MEMORANDUM

SUBJECT: July 28, 2026 HISTORIC PRESERVATION COMMISSION MEETING

STAUNTON HISTORIC PRESERVATION COMMISSION**June 23, 2026****5:30 p.m.****Council Chambers**

HSF Recommendation

NE-facing
proposed

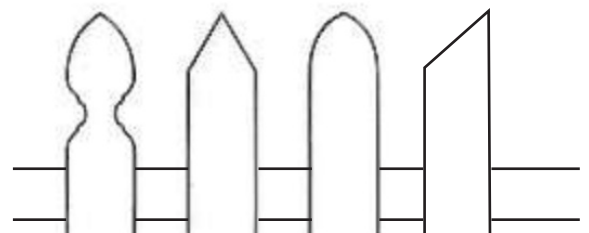
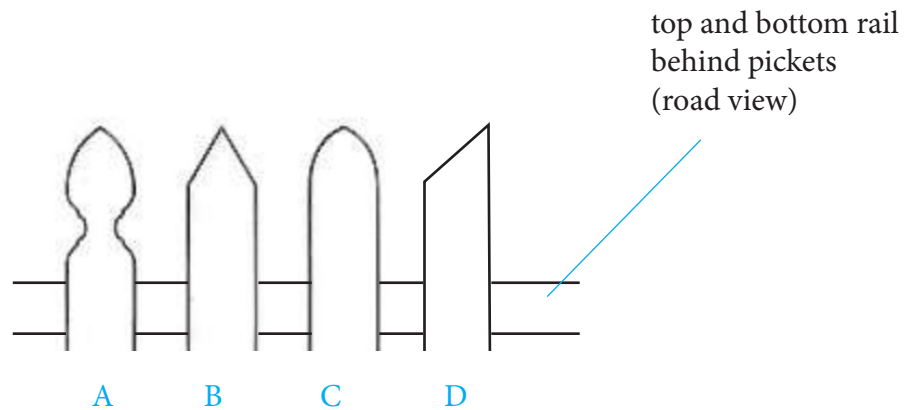
Proposing a 3 ft. painted wooden picket fence (color to match building). Profile to match similar fences in the neighborhood. Fence and posts to be installed outside of sidewalk border, and inside the property line.

Horizontal rails to be on property-side with pickets facing street-side.
